UNITED STATES PATENT AND TRADEMARK OFFICE

APPLICATION NO.	FILING DATE	FIRST NAMED INVENTOR	ATTORNEY DOCKET NO.	CONFIRMATION NO.
10/090,146	03/05/2002	Chikaho Ikeda	112116	5449
25944	7590	08/10/2005	EXAMINER	
OLIFF & BERRIDGE, PLC P.O. BOX 19928 ALEXANDRIA, VA 22320			FLORES RUIZ, DELMA R	
			ART UNIT	PAPER NUMBER
			2828

Office Action Summary

DETAILED ACTION

Discloses Fig. 2, by Kikuchi

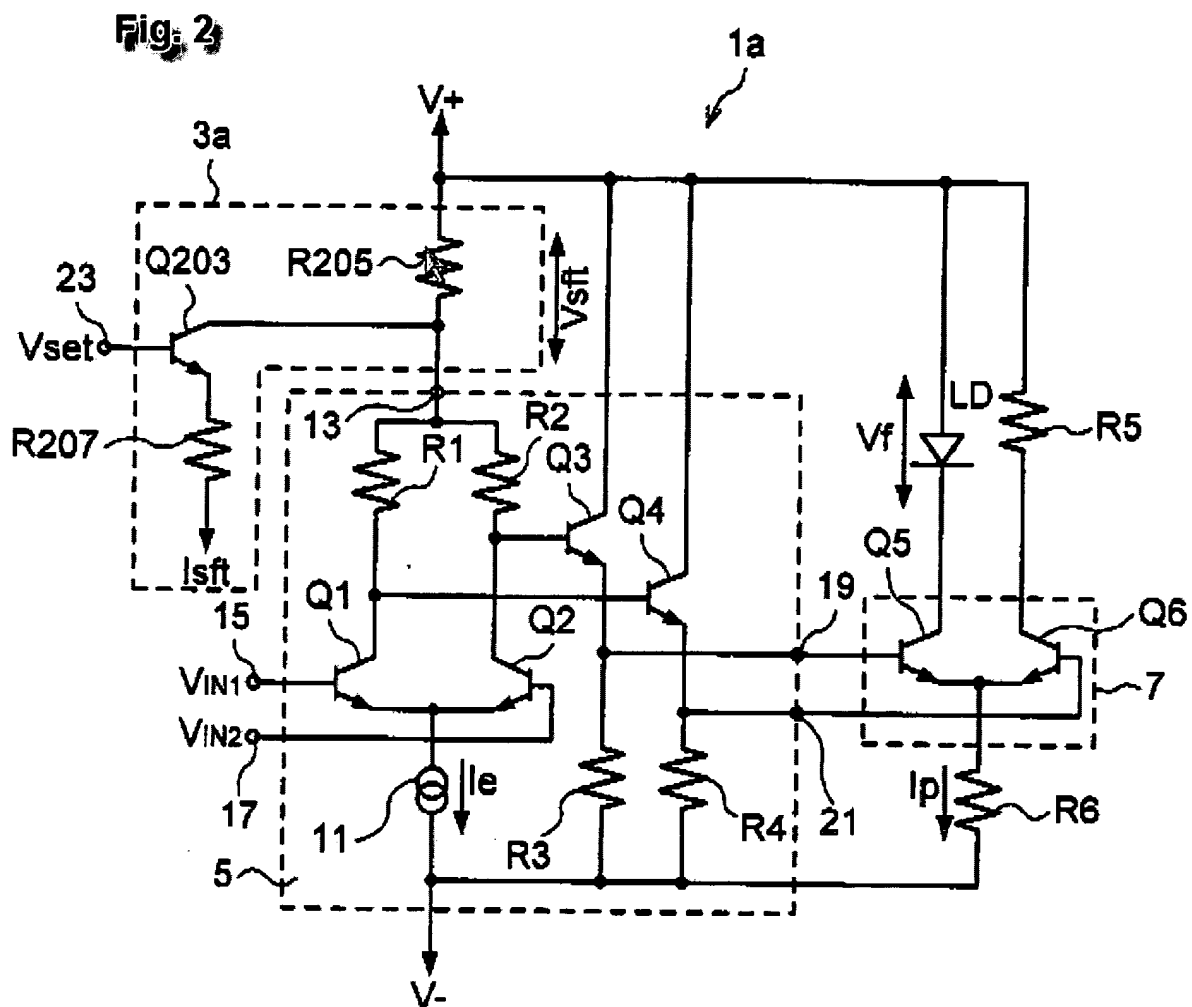
Claim 14 is rejected under 35 U.S.C. 102(e) as being anticipated by Kikuchi (6,510,168).

Regarding claim 14 Kikuchi discloses an apparatus for driving a light emitting element in response to input data, the light emitting element emitting light by causing a direct current to flow thereto, (see Fig. 2, Character 1a) the apparatus comprising: a voltage driving section (see Fig. 2, Characters V+ and V-) for driving the light emitting element (see Fig. 1, Character LD) with voltage; a current driving (see Fig. 2, Character Ip) section for driving the light emitting element with a current; and a switching section (see Fig 2. Character 7) for changing voltage drive by the voltage driving section and current drive by the current driving section based on the input data (see Fig. 2, Abstract, Column 1, Lines 52 – 55, Column 4, Lines 1 – 57).
